# Decommissioning What's At Stake?

Lynnette Hendricks, NEI

11/8/99

# **Risk Informing Decommissioning Regulations**

**Figure 5-1**  
**COMPARISON OF POINT ESTIMATES**

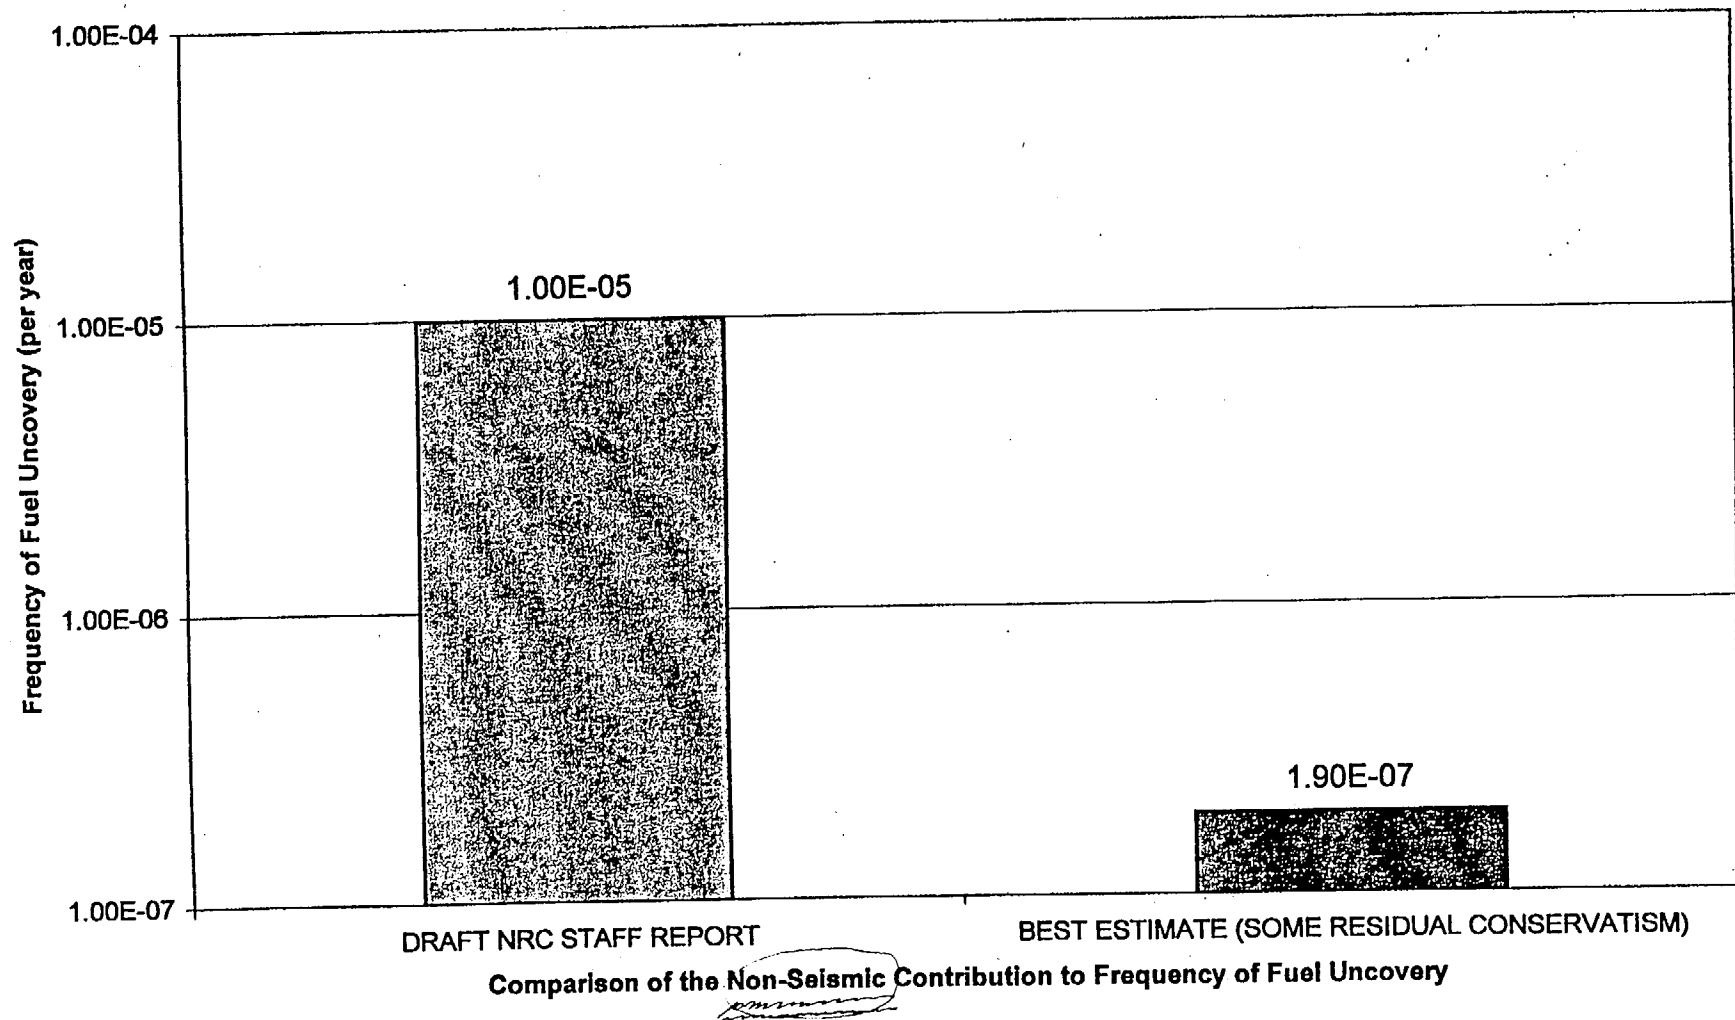
# Fuel Uncovery Endpoint

- Not related to public risk
- Postulated runaway oxidation correlates with risk to public
- Realistic heatup and endpoint adds 3 days to recovery time! (8 days Vs. 5)

- Credit industry commitments
- Revise study to:
  - Use best estimates
  - Remove conservatisms
- Truncate sequences beyond 2 days
- Requantify Model
